SS - 1033273: WST 5700XE Sun Visor Cracks - Mounting Screws Loose

WST 5700XE

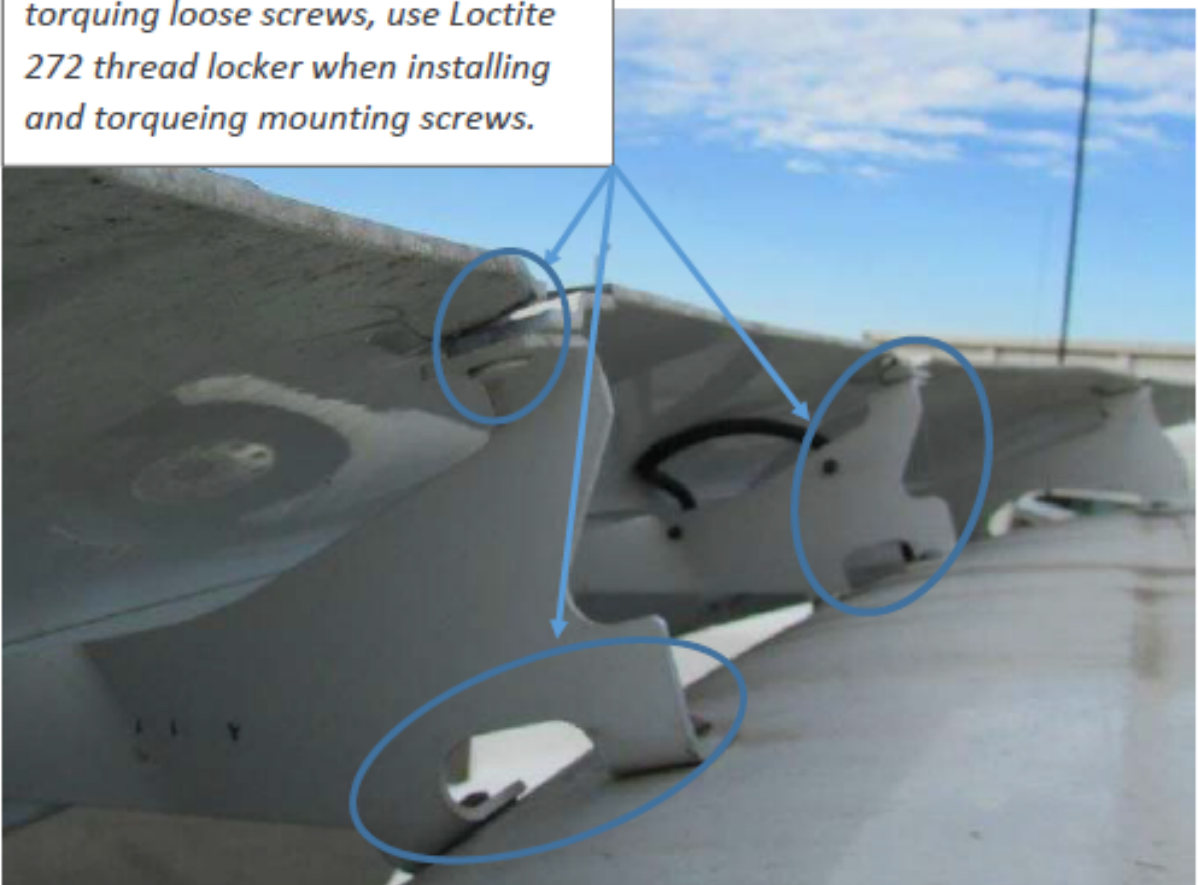
Sun Visors cracking and Sun Visor mounting screws loose.

Reports of sun visors cracking and/or mounting screws loose have been received from some areas with windy conditions.

When replacing the Sun Visors, installing/torqueing the mounting screws (or removing and retorquing loose mounting screws) it is recommended to use Loctite 272:

When replacing Sun Visor or re-torquing loose screws, use Loctite 272 thread locker when installing and torquing mounting screws.
